ADDENDUM NUMBER 1

Issued: July 29, 2016

**North Bay Water Reuse Program  
Sonoma Valley County Sanitation District Treatment Plant  
Pumping and Piping Upgrades**

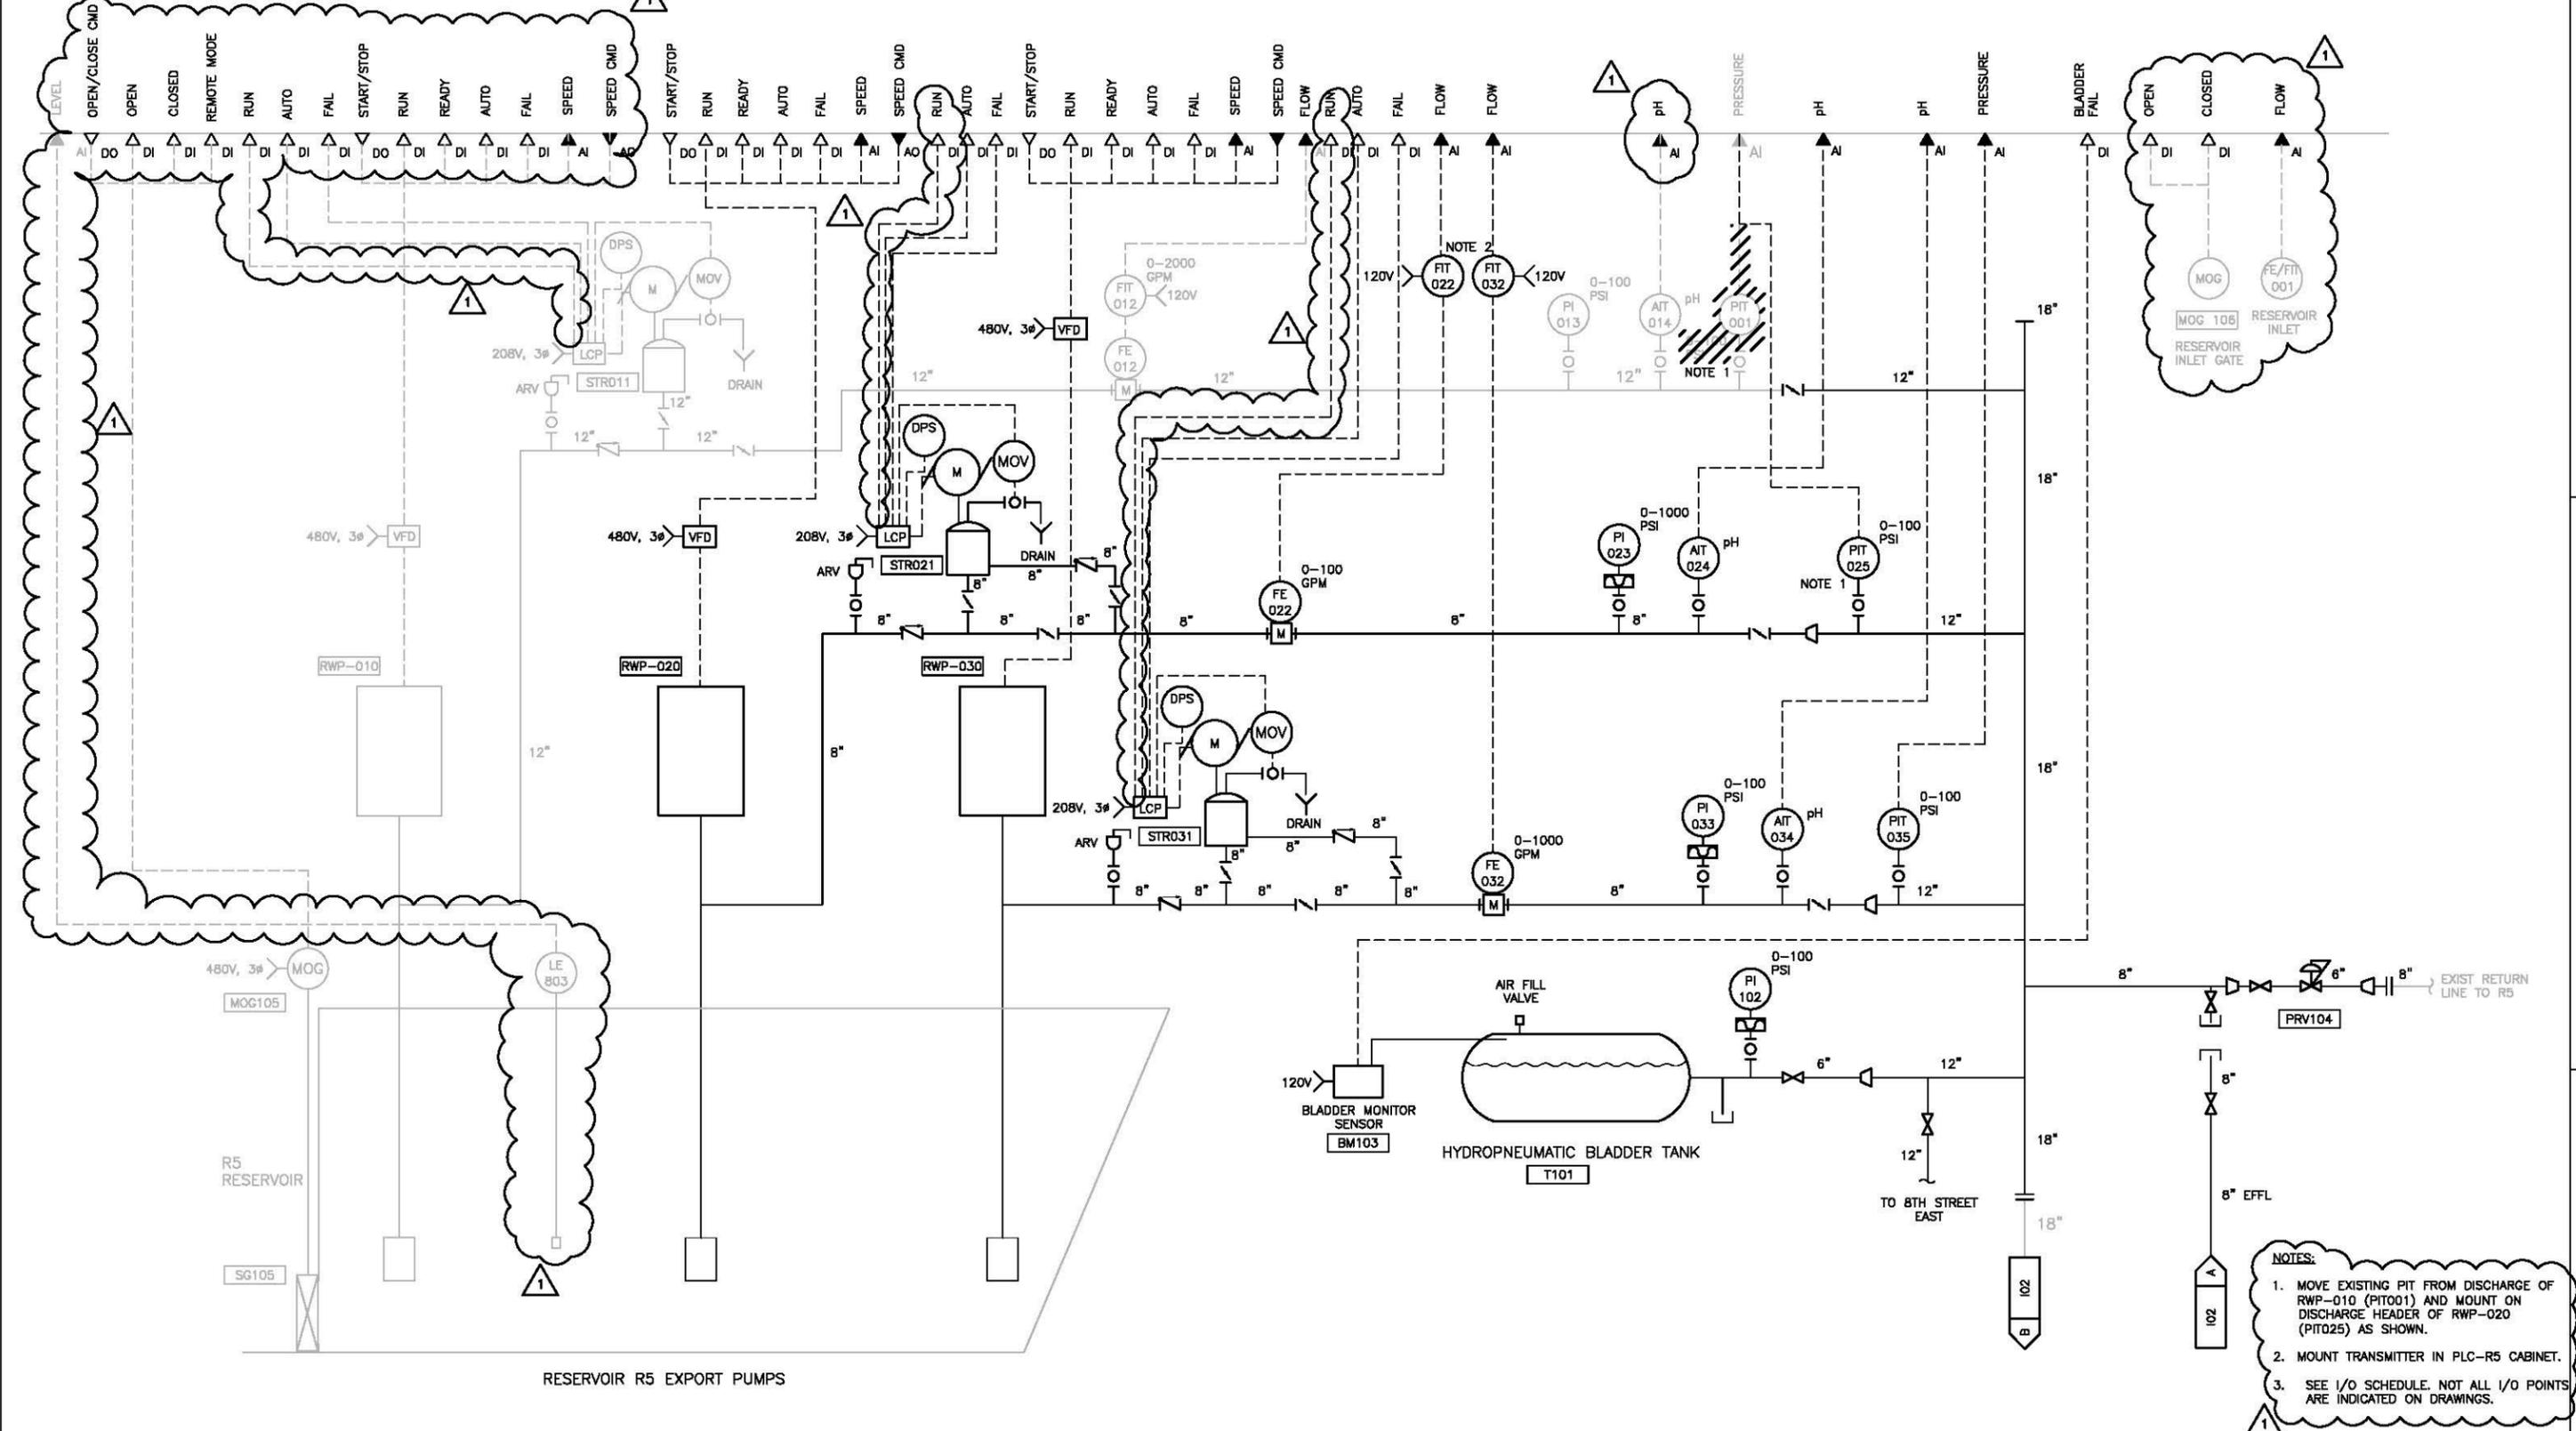
- I. The specified automatic self cleaning filters for this project we sent the specifications to Amiad for a project quote. I have attached a letter from Amiad for this project for clarification on. Please review the letter with outlined questions that are in line with the written specification so we can identify these and quote the correct filter.

Owner's response: This question will be answered in a subsequent Addendum.
